1 Document control

FRNSW reference number **FRN23/3142**

Premises name	Blakebrook Public School
Primary street address	417 Rosehill Road
Secondary street address	Secondary street address (if applicable)
Premises suburb	Blakebrook NSW 2480
Lot and DP numbers	Lot 2, DP859866
Is the premises considered a significant development or a unique building (e.g. Sydney Football Stadium, Sydney Opera House, Crown Towers, etc.)?	No

Figure 15: Undercroft area

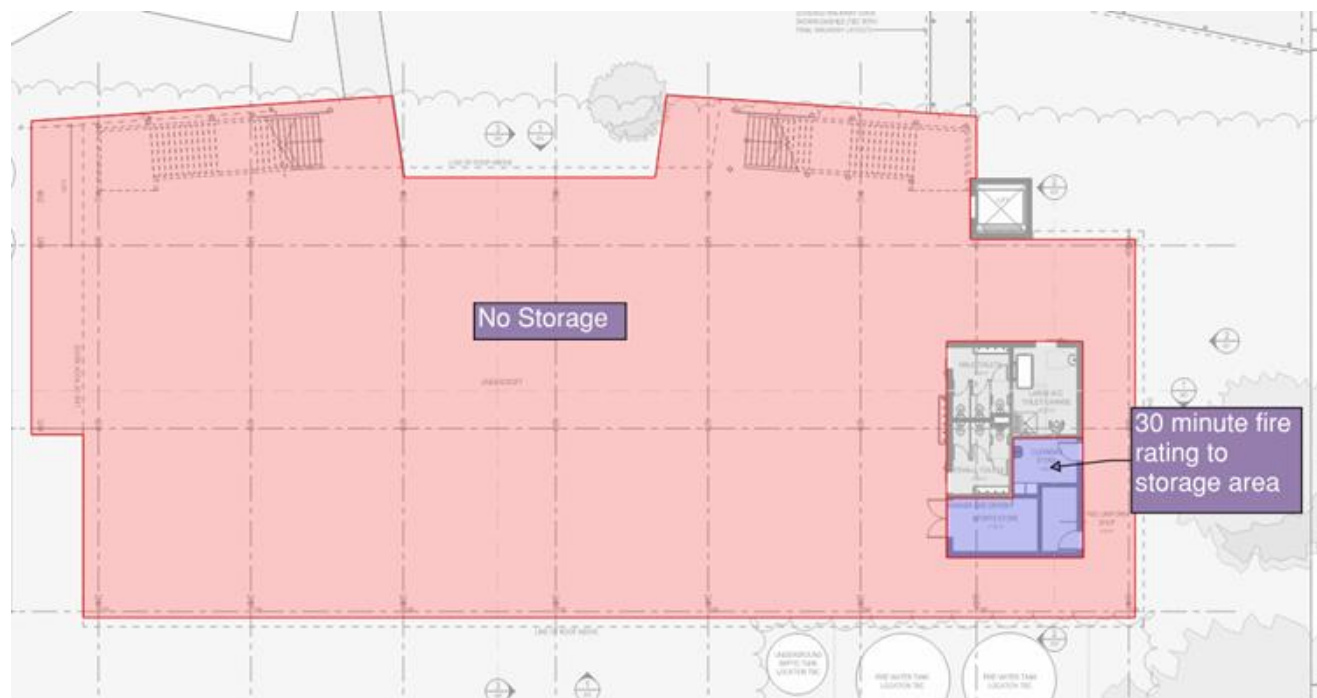
FRNSW Comment: FRNSW recommend management in use procedures be implemented to ensure the sterile requirements of the space are maintained accordingly.

Figure 21: Floor Area Calculation

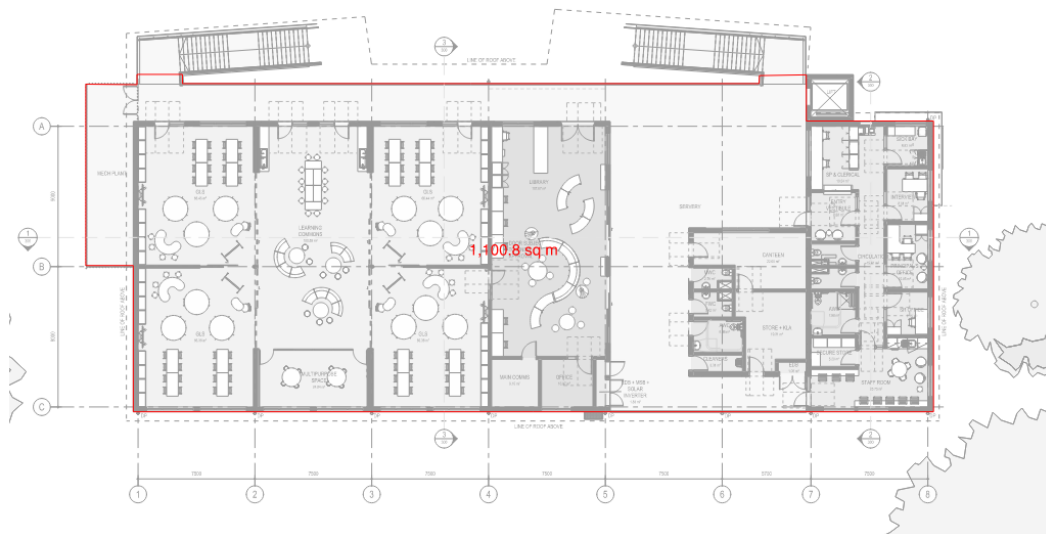
FRNSW Comment: FRNSW must consider the remoteness of the building with no detection or sprinklers and factor in that the fire would be well-developed before crews arrived and it would be expected that crews would utilise more than one hydrant extinguish.

FRNSW Comment: FRNSW assume that full hydrant coverage will still be achieved as no hydrant plan has been provided.
